Invitation to Bid No. 95-2017

Construction Services for Fire Station No. 24

LEXINGTON FIRE STATION 24

ISSUED FOR: ADDENDUM 2	DRAWN BY: DE	CHECKED BY: DE	SCALE: 1/8"=1'-0"	DATE: 10/4/2017	SHEET: E-101A
---------------------------	-----------------	-------------------	----------------------	--------------------	------------------

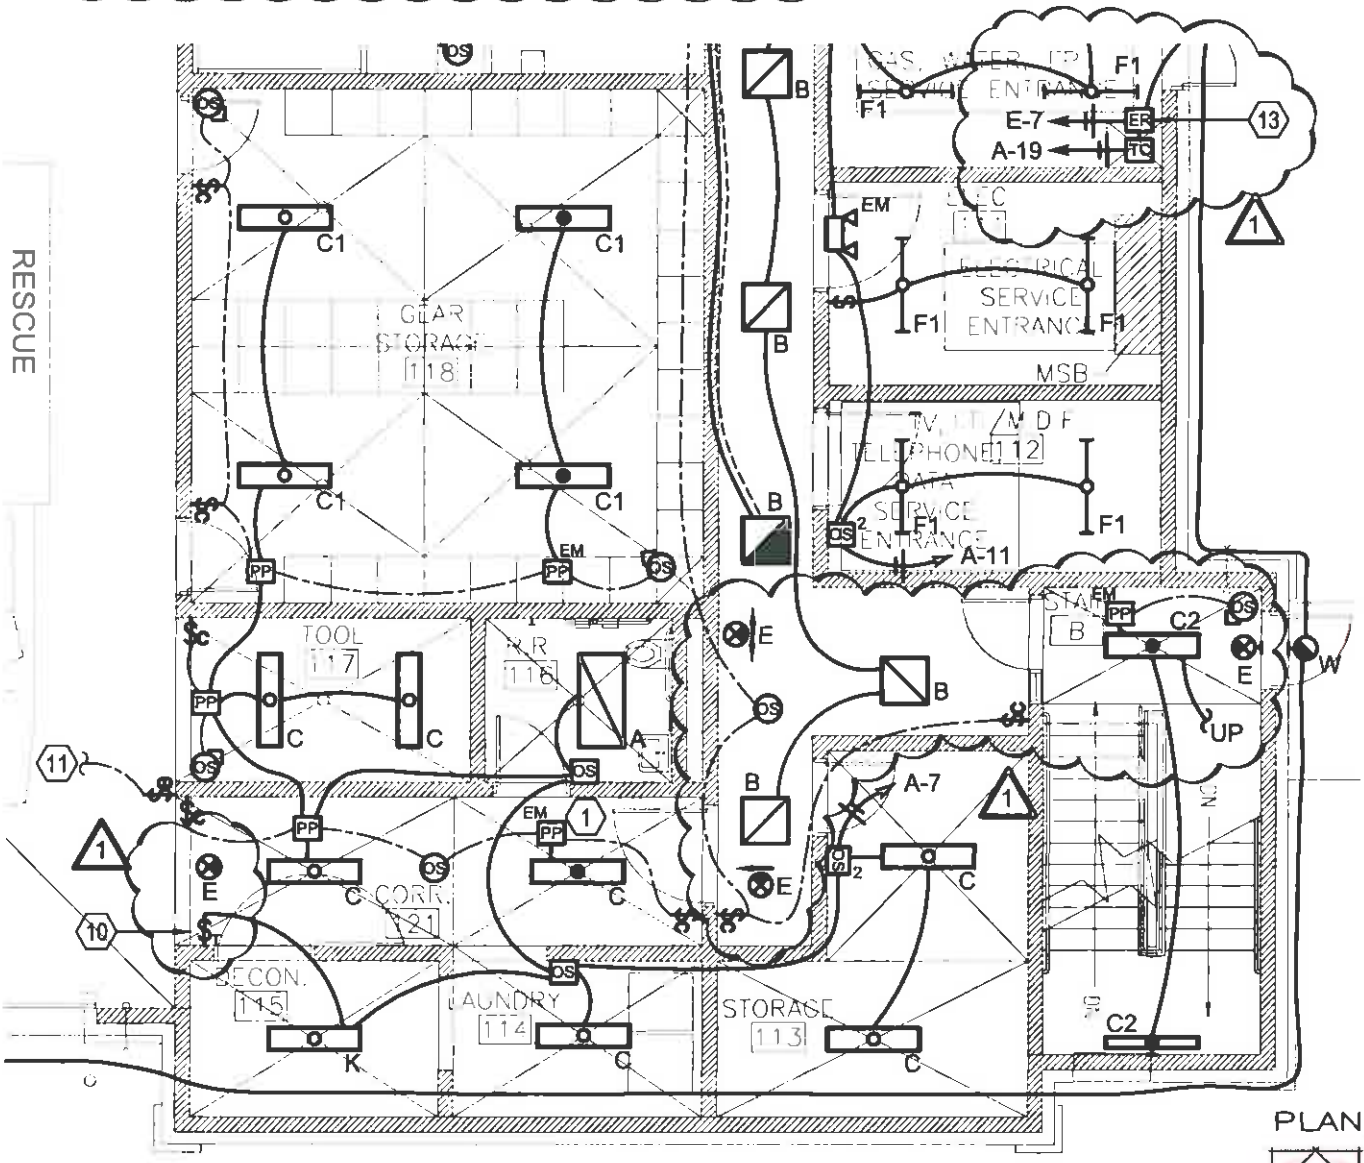
- e. Relocate type "E" exit sign in corridor outside Stair B on first floor to above door into Corridor 121.
 - f. Refer to attached drawing E-101A and revise exit sign locations in Corridor outside Stair B, exterior lighting control and add emergency bypass and occupancy sensor control in Stair B.

ISSUED FOR: 1 ADDENDUM 2	DRAWN BY: DE	CHECKED BY: DE	SCALE: 1/8"=1'-0"	DATE: 10/4/2017	SHEET: E-101B
-----------------------------	-----------------	-------------------	----------------------	--------------------	------------------

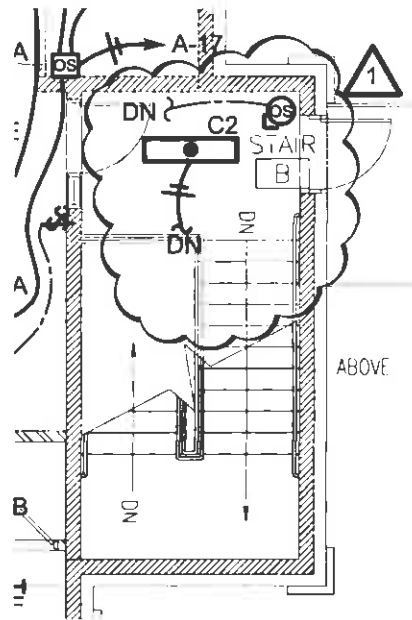
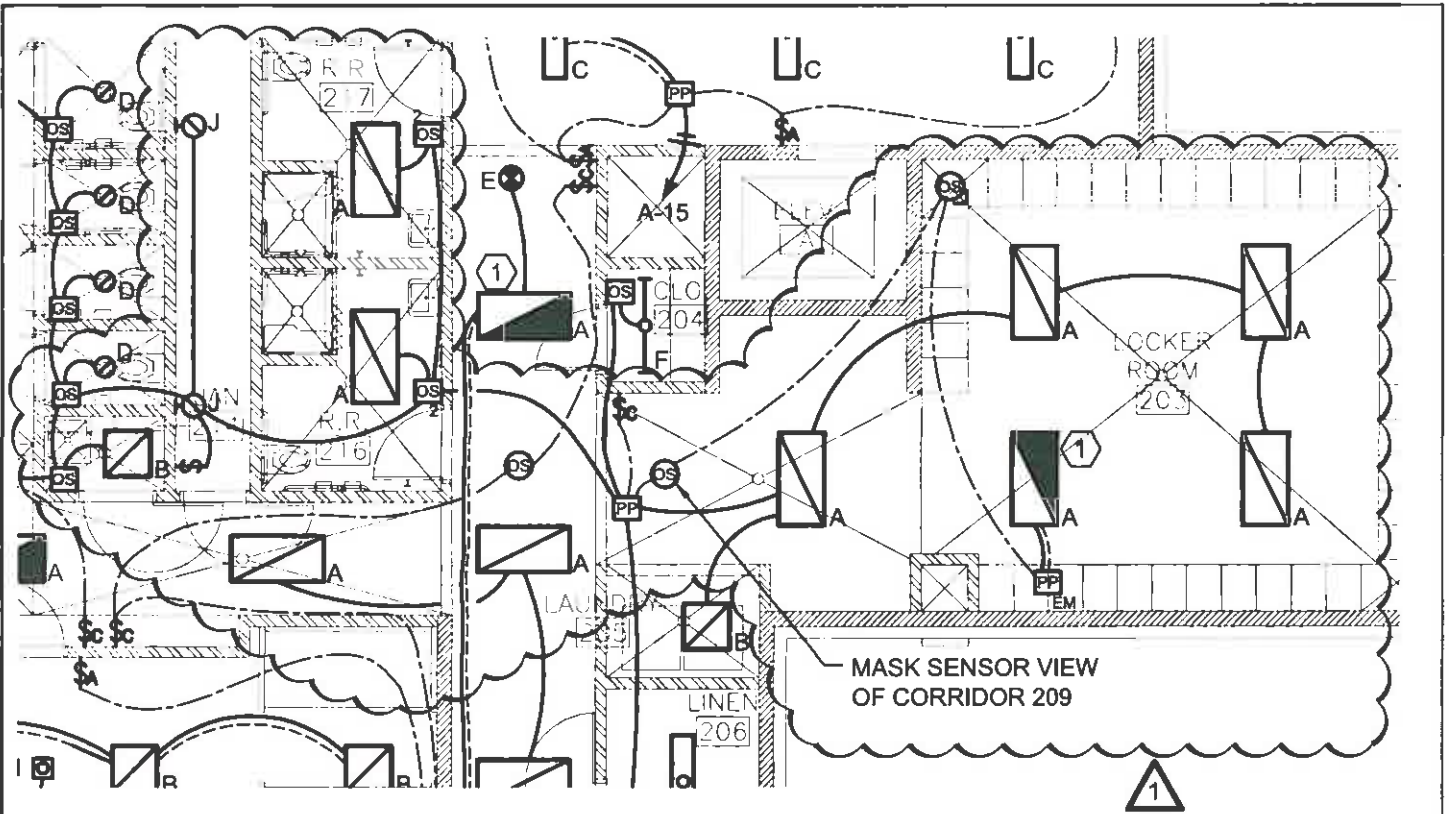
- g. Vestibule 105: Untagged light fixture to be type "B"
 - h. Refer to attached drawing E-101B and revise occupancy sensor switch type in restrooms 216 and 217, add service lighting in plumbing chase, revise occupancy sensor locations in locker room 203 and add occupancy sensor control in Stair B.

ISSUED FOR: 1	ADDENDUM 2	DRAWN BY: DE	CHECKED BY: DE	SCALE: 1/8"=1'-0"	DATE: 10/4/2017	SHEET: E-503A
------------------	------------	-----------------	-------------------	----------------------	--------------------	-------------------------

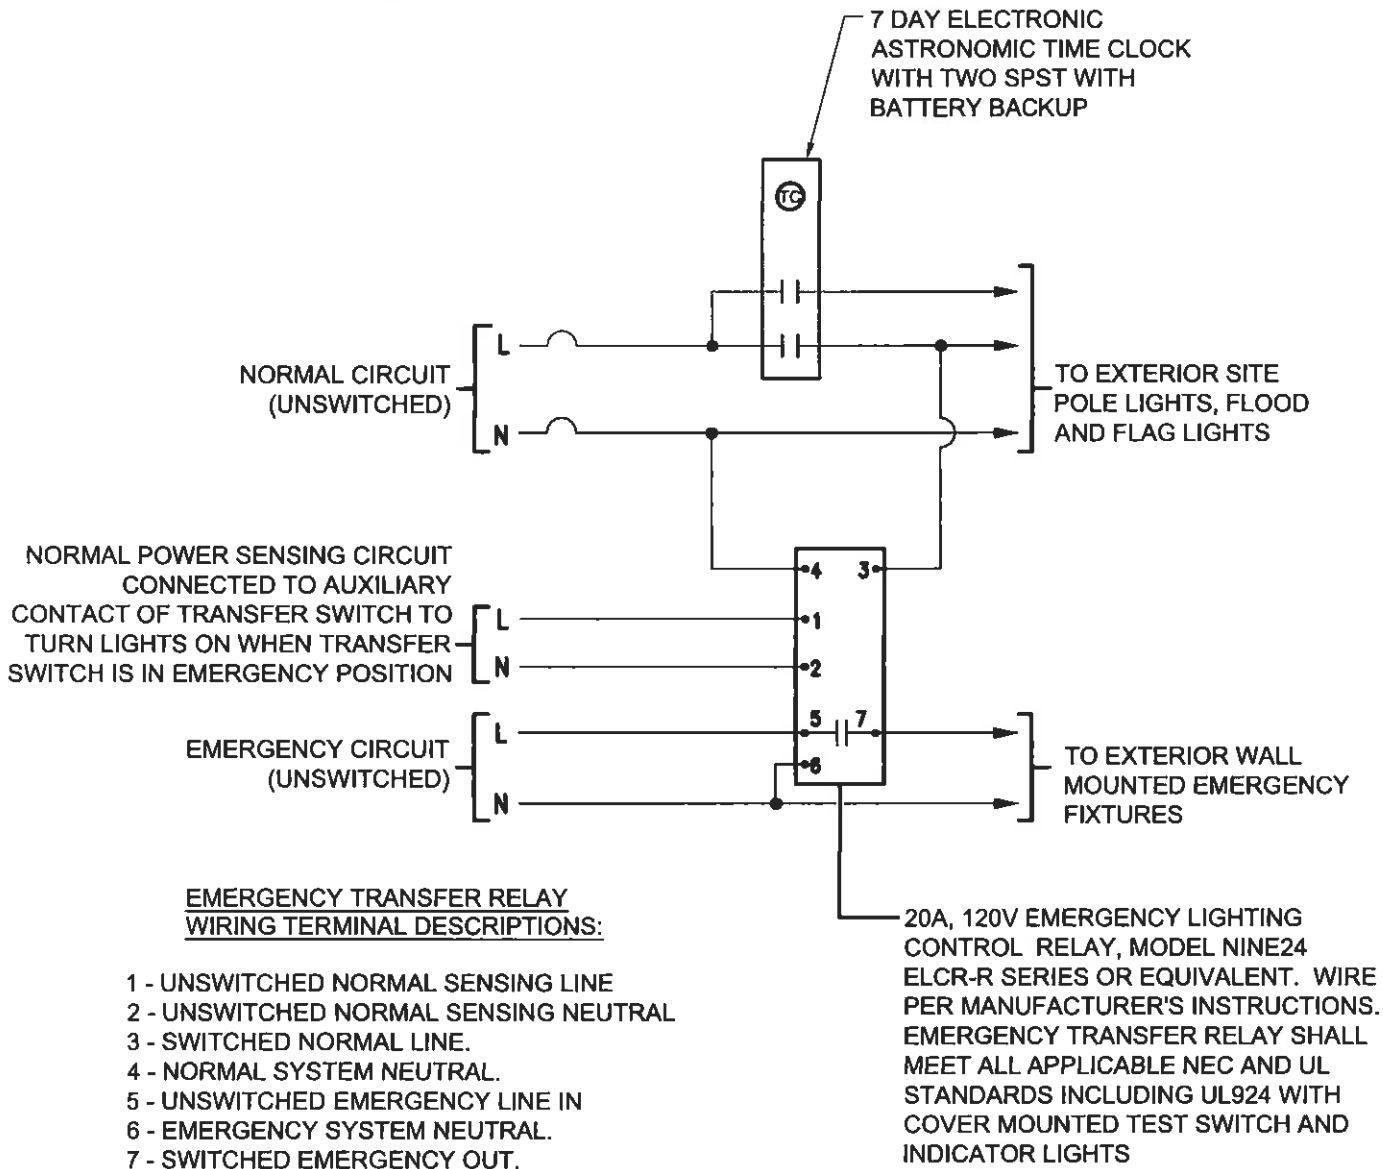
- c. Detail A/E-503: Delete this detail in its entirety, lighting controls will be stand-alone
 - d. Detail F/E-503: Refer to attached drawing E-503A for revised exterior lighting control.

SHEET: FP-101A

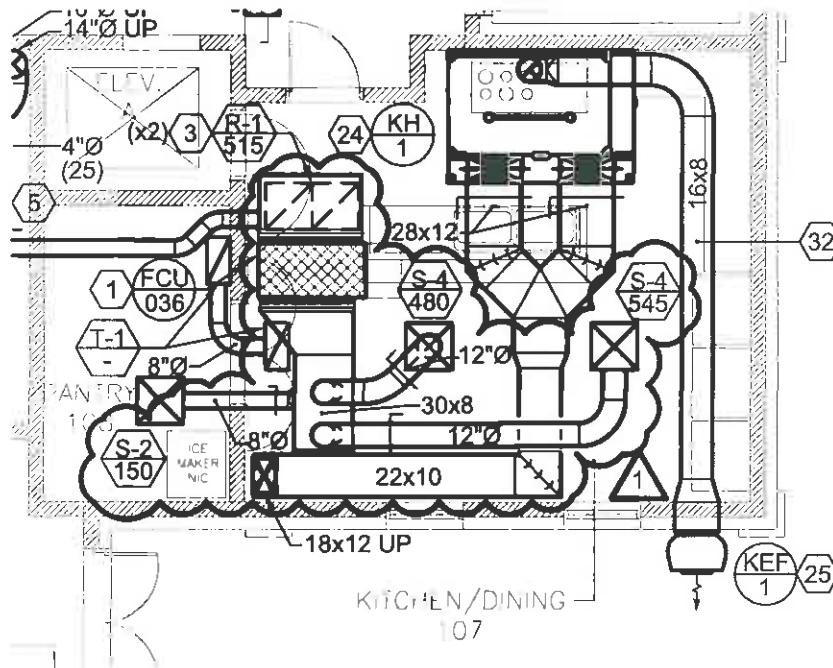
- c. Revise sheet note #17 to 3/4" gas.
 - d. Revise sheet note #18 to 3/4" gas.
2. Refer to Sheet FP-101A:
 - a. Revise sheet note #7 to read as follows:
"HOOD SUPPRESSION SYSTEM PROVIDED AS PART OF HOOD SYSTEM. REFER TO M-101 FOR ADDITIONAL INFORMATION."

DRAWN BY:	CHECKED BY:	SCALE:	DATE:	SHEET:
BG	NM	1/8" = 1'-0"	10/3/2017	P-201B

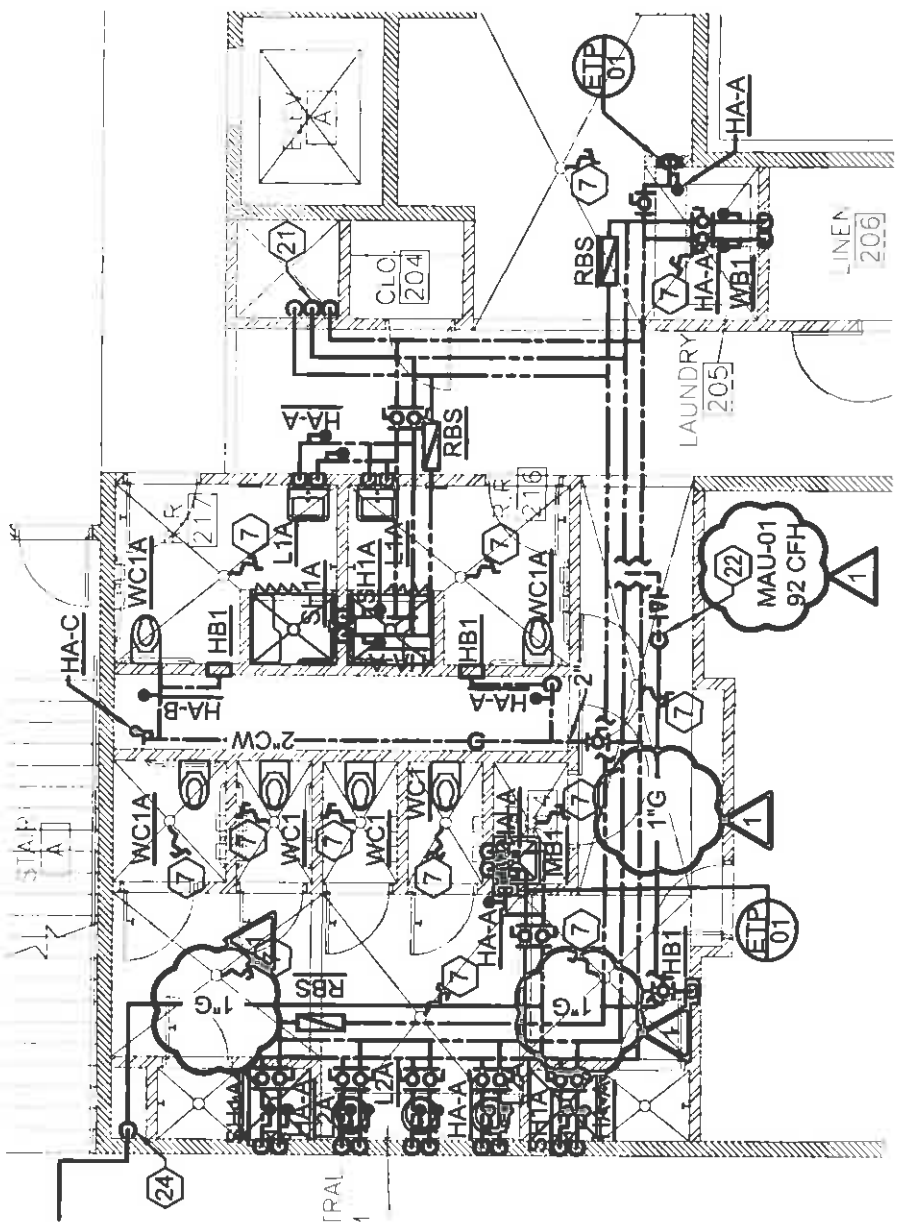
- a. Added plan note indicating gas pressure to building of 2 PSI downstream of the meter / regulator.
7. Refer to Sheet P-201B:
 - a. Added pipe line sizes to gas piping.

- b. Revise sheet note #16 to read as follows:
"3/4" GAS TO GRILL; GRILL PROVIDED BY OWNER. VERIFY FINAL LOCATION WITH ARCHITECT. SHUTOFF VALVE AND REGULATOR 24" AFG."

16. 3/4" GAS TO GRILL; GRILL PROVIDED BY OWNER. VERIFY FINAL LOCATION WITH ARCHITECT. SHUTOFF VALVE AND REGULATOR 24" AFG.

LEXINGTON - LOUISVILLE 628 Winchester Road Lexington, KY 40505 t. 859 277 8177 www.stweeng.com		LEXINGTON REPLACEMENT FIRE STATION No. 24 2754 MAGNOLIA SPRINGS DRIVE LEXINGTON, KY 40511	
	ISSUED FOR: ADDENDUM #1 10.3.2017	DRAWN BY: BG	CHECKED BY: NM	SCALE: 1/8" = 1'-0"
			SHEET: P-401A

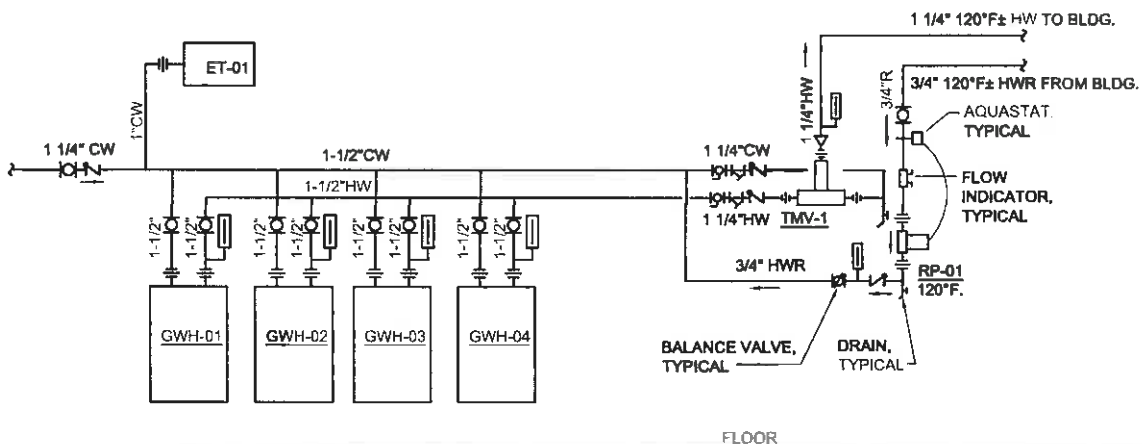
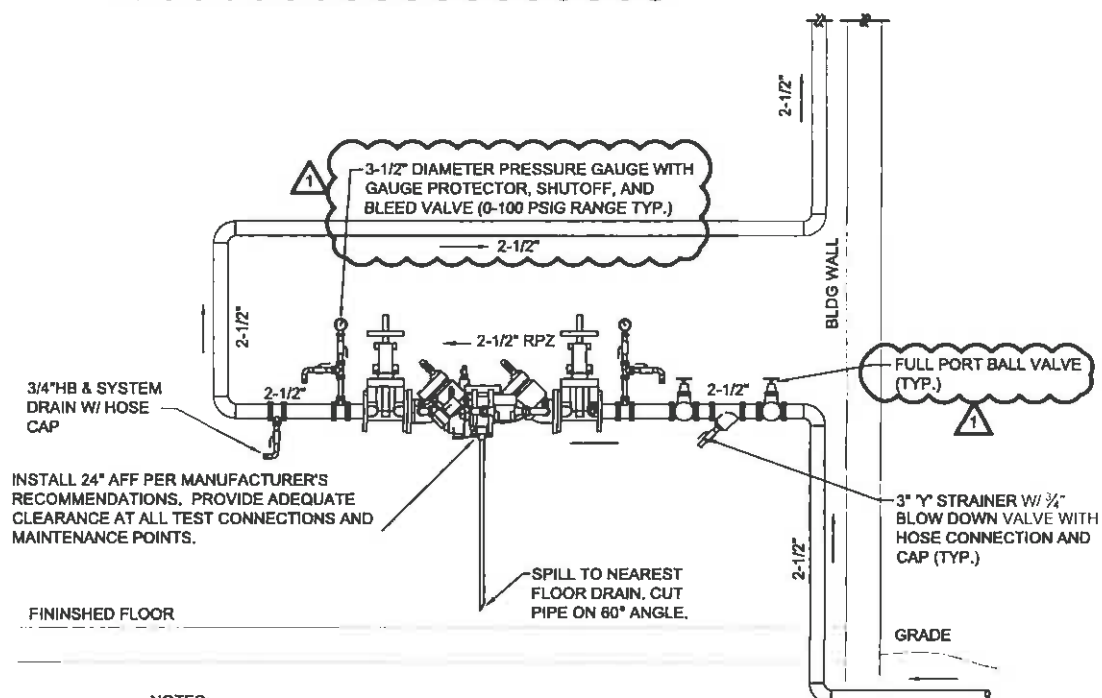
- b. Change TMV-B to TMV-2.
10. Refer to Sheet P-401A:
 - a. Refer to Water Heater Piping Schematic, revise as follows:
 - i. Add note #9
 - ii. Revise title.

SHEET: SU-101A

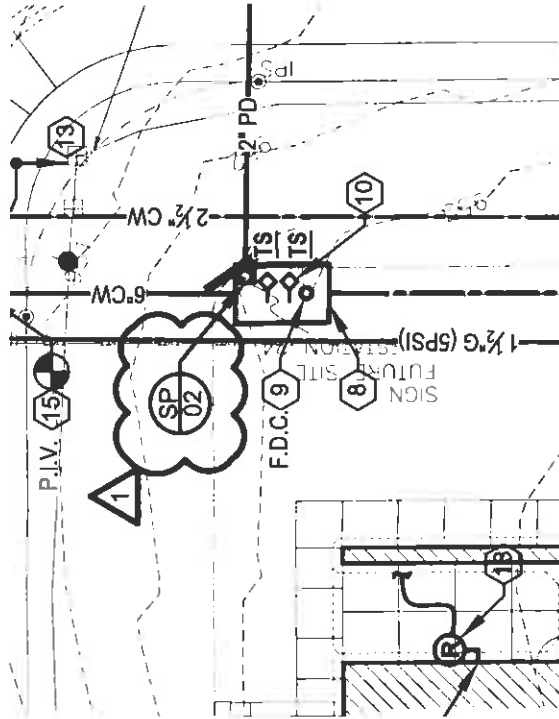
1. Refer to Sheet SU-101A:
 - a. In the fire vault change SP-01 to SP-02.
 - b. Revise general note #1 to read as follows:
"CONTRACTOR SHALL OBTAIN PROPER PERMITS, AND FOLLOW ALL REQUIREMENTS FOR TRAFFIC ON ALL UTILITY CUTS ON MAGNOLIA SPRINGS AND MABEL DRIVE INCLUDING BUT NOT LIMITED TO TRAFFIC SIGNAGE, FLAGGERS, BARRIERS, AND OPEN TRENCH COVERS."

1. CONTRACTOR SHALL OBTAIN PROPER PERMITS, AND FOLLOW ALL REQUIREMENTS FOR TRAFFIC ON ALL UTILITY CUTS ON MAGNOLIA SPRINGS AND MABEL DRIVE INCLUDING BUT NOT LIMITED TO TRAFFIC SIGNAGE, FLAGGERS, BARRIERS, AND OPEN TRENCH COVERS.
2. COORDINATE ALL WORK WITH C-101 AND SU2.1.
3. REFER TO SHEET SU-102 FOR SITE UTILITY DETAILS AND NOTES.

17. 3/4" GAS. REFER TO P-201 FOR CONTINUATION.
18. 3/4" GAS TO GRILL PROVIDED BY OTHERS. VERIFY FINAL LOCATION WITH ARCHITECT. SHUTOFF VALVE AND REGULATOR 24" AFG.
